STAFF RECOMMENDATION

320 South 15th Street

Application: New Construction—Addition; Partial Demolition

Description of Project: Applicant proposes to remove roof of existing, non-contributing structure; to reconstruct a new, taller roof with dormers; and to add a cover and an exterior stair to the existing deck. The project does not include an increase in footprint.

Figure 1. 320 South 15th Street

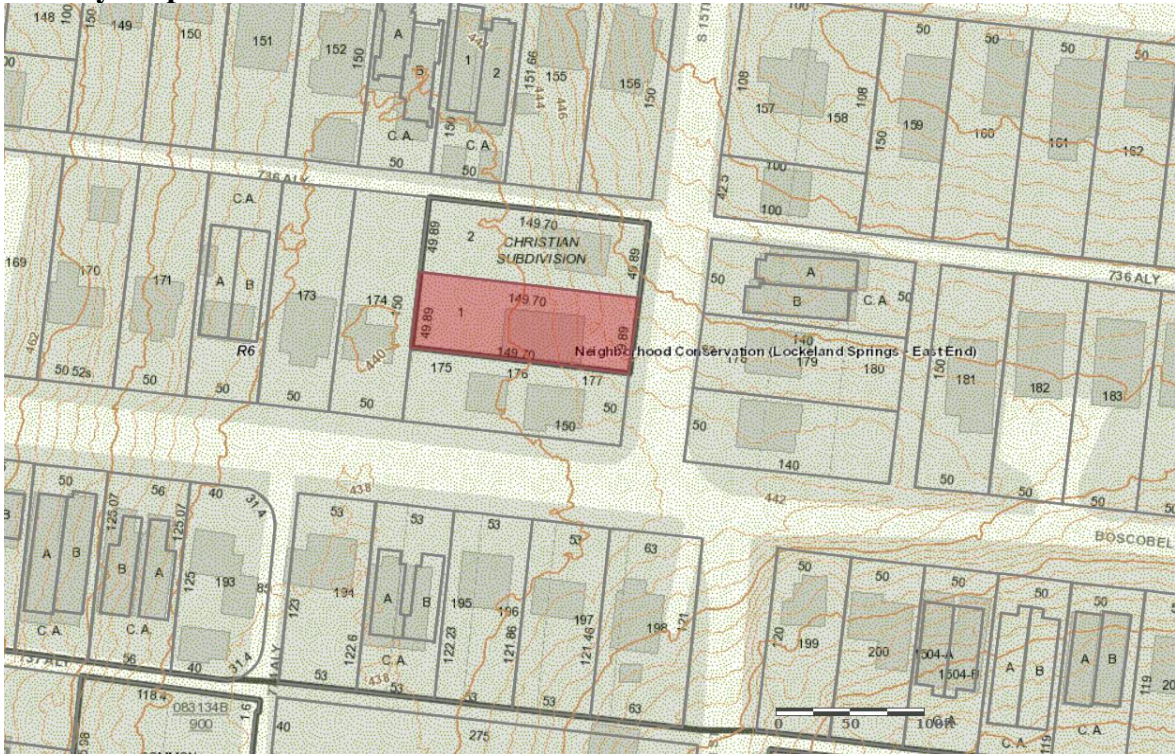
Background: 320 South 15th Street was constructed c. 2006, prior to the expansion of the Lockeland Springs-East End Neighborhood Conservation Overlay.

EXTERIOR
ELEVATIONS

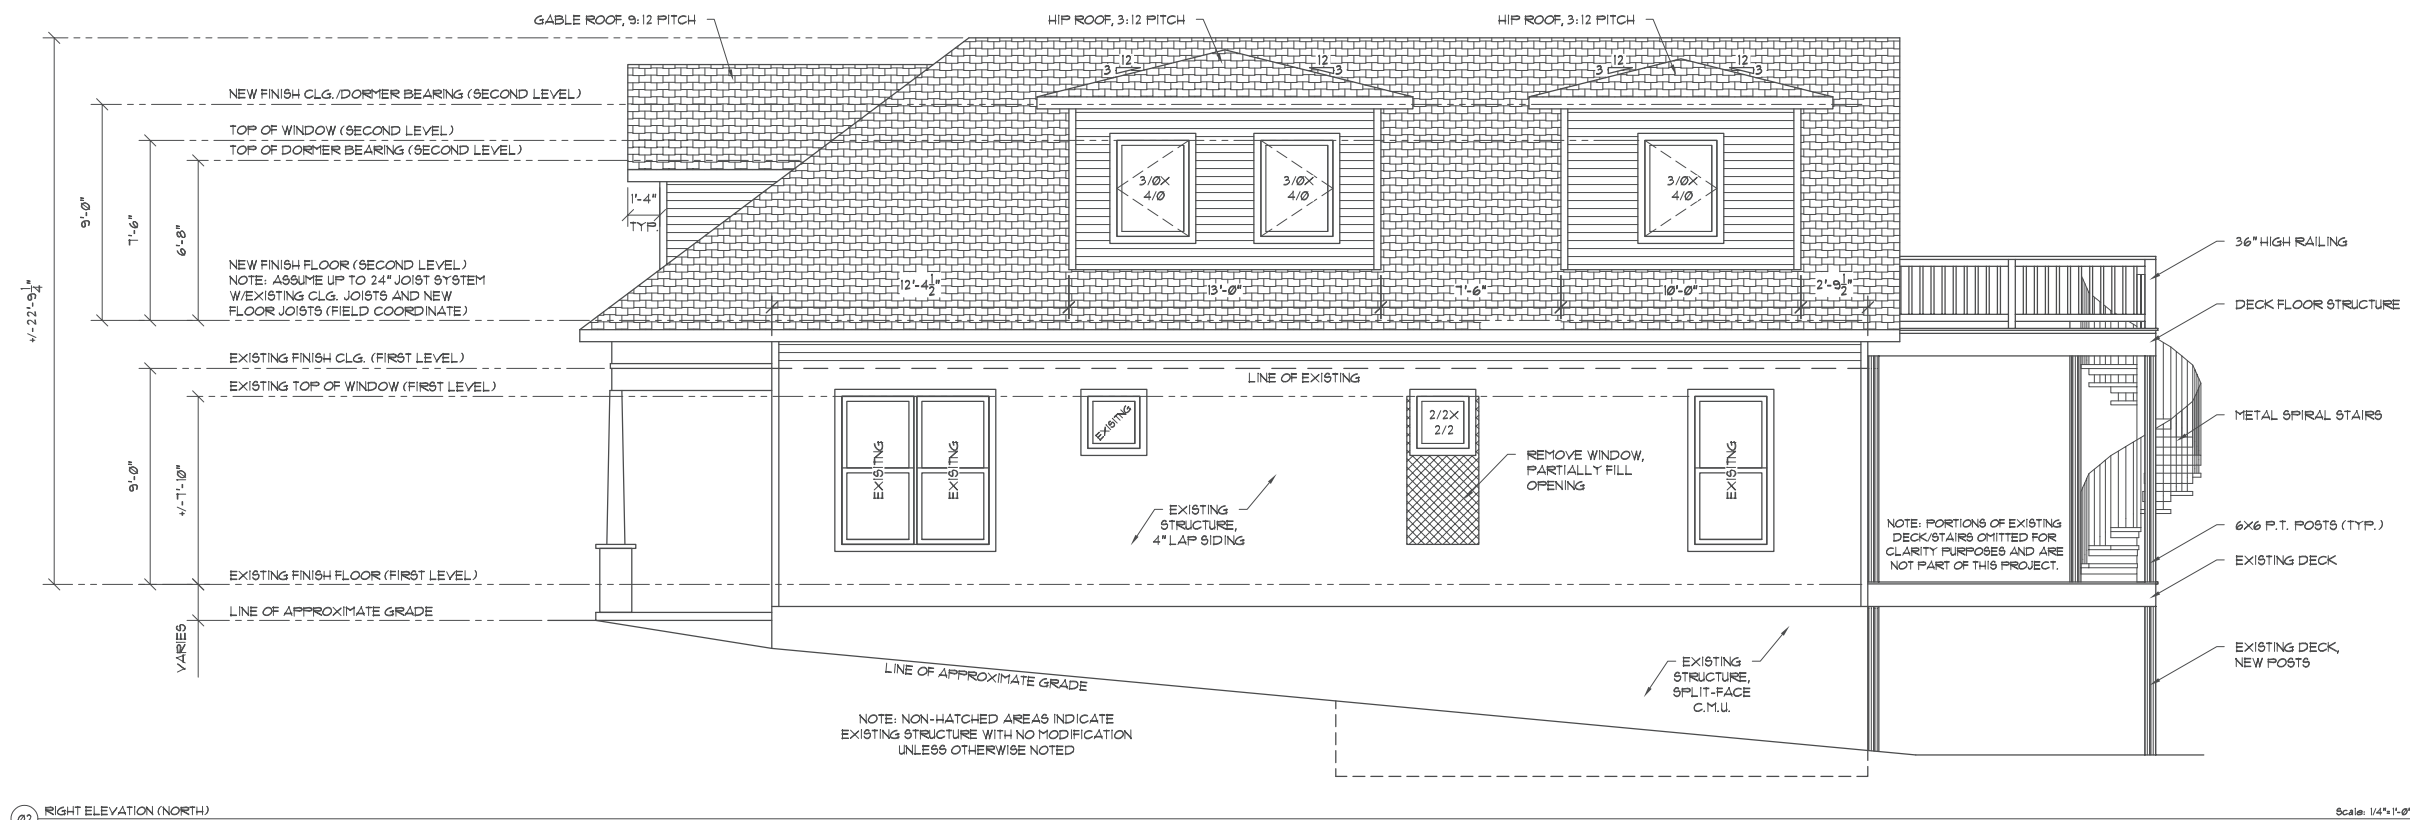
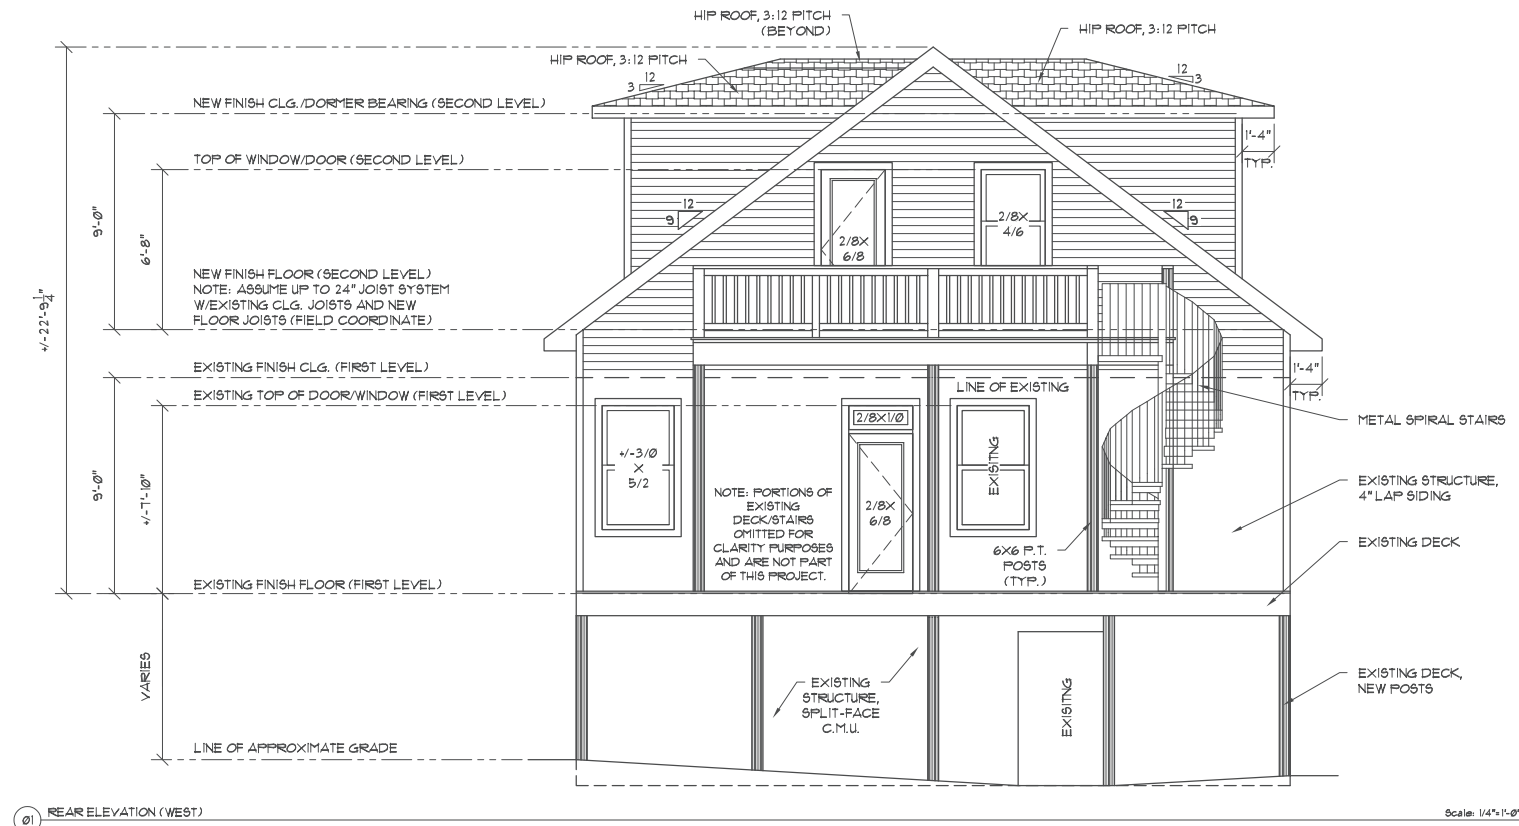
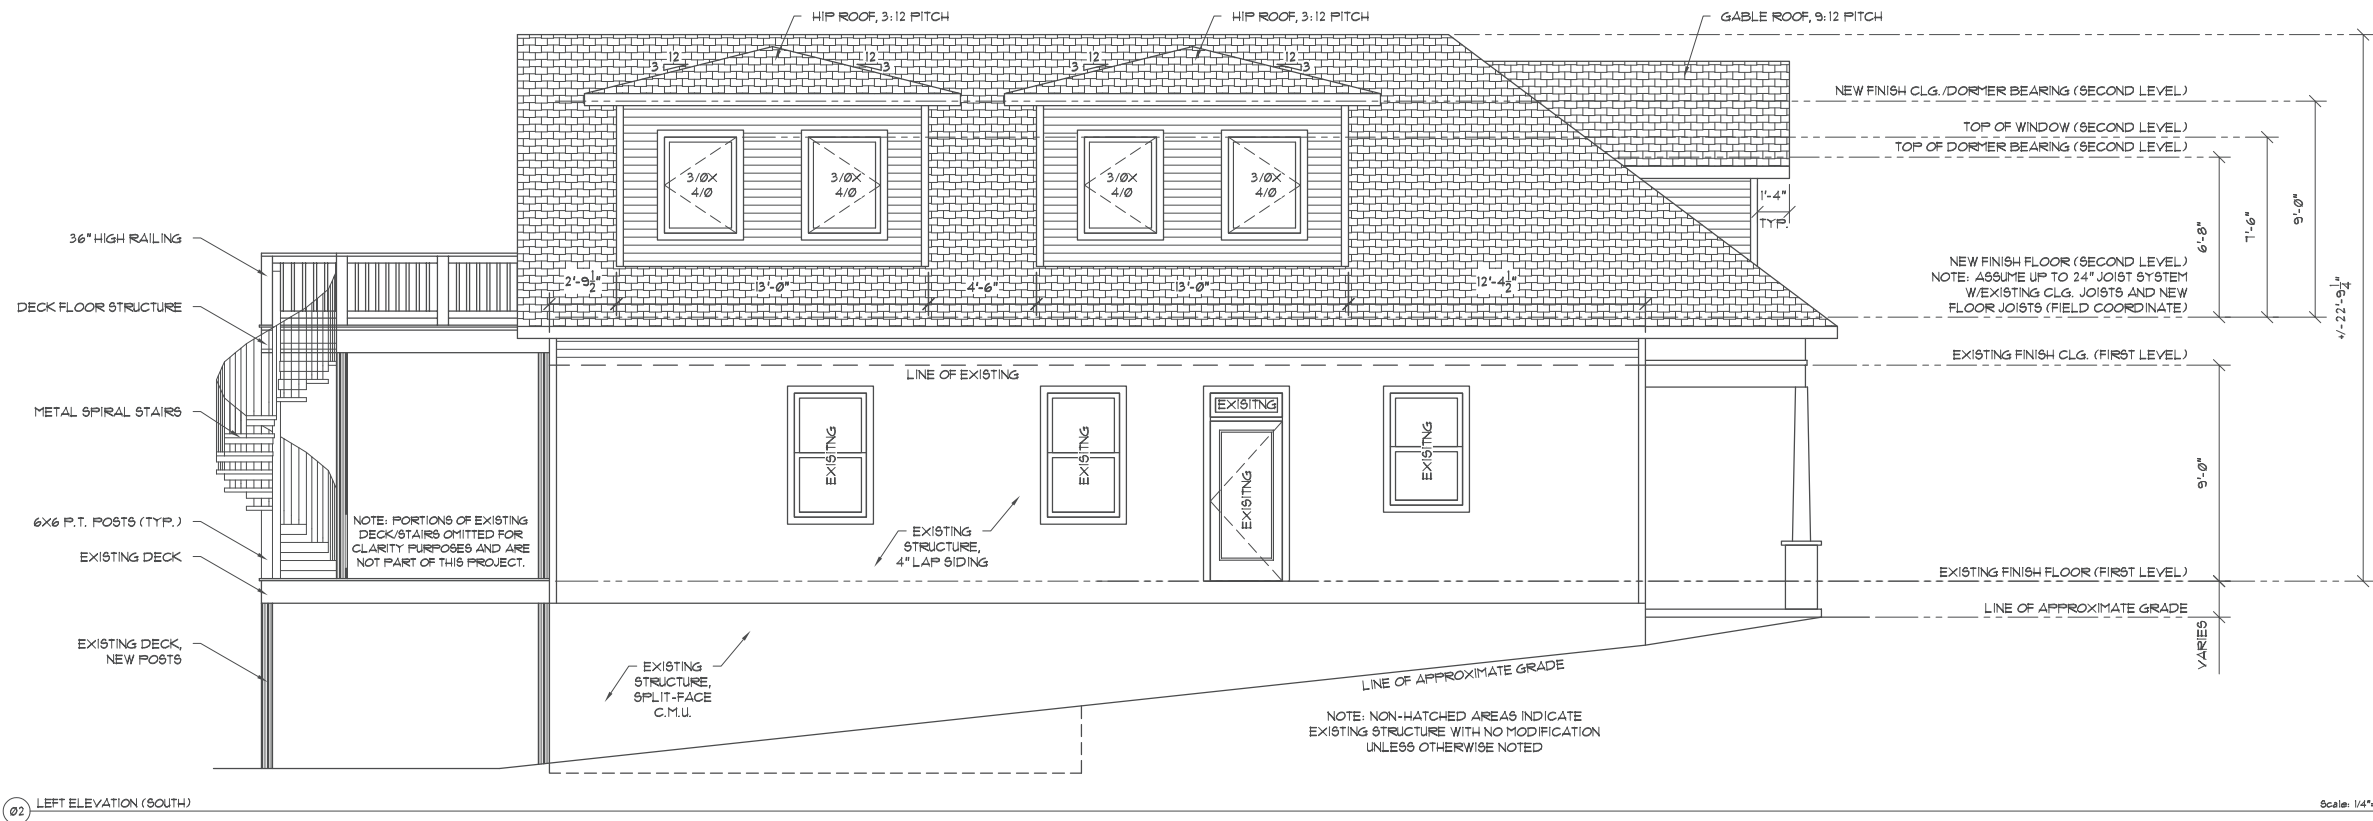
Height & Scale: The addition does not include a change in footprint. The new eave height will also remain the same, but the house’s ridge will increase from approximately twenty feet (20’) to twenty-four feet (24’). The house will retain its one-and-a-half story scale with the addition. Staff finds that the height of twenty-four feet (24’) to meet the historic context, where historic houses are one to one-and-a-half stories with heights ranging from nineteen to twenty-eight feet (19’-28’).

Roof form: The new roof will be hipped on three sides with a gable on the rear. The 9/12 pitch is similar to historic hipped roofs in the immediate vicinity. The new front dormer is gabled with a 9/12 pitch to match the main roof slope. The side dormers are hipped with a 3/12 pitch. These dormers are inset two feet (2’) from the wall below and are set off the ridge of the main roof. Staff finds that the scale of the dormers meet the design guidelines.

Proportion and Rhythm of Openings: The change to the window opening on the right façade is discussed under “Partial Demolition.” The windows in the new dormers are appropriate to the scale of the dormers.

Staff finds that the proposed roof forms to meet Sections II.B.5. and II.B.10. of the design guidelines.

Staff finds the project’s proportion and rhythm of openings to meet Sections II.B.7. and II.B.10. of the design guidelines.
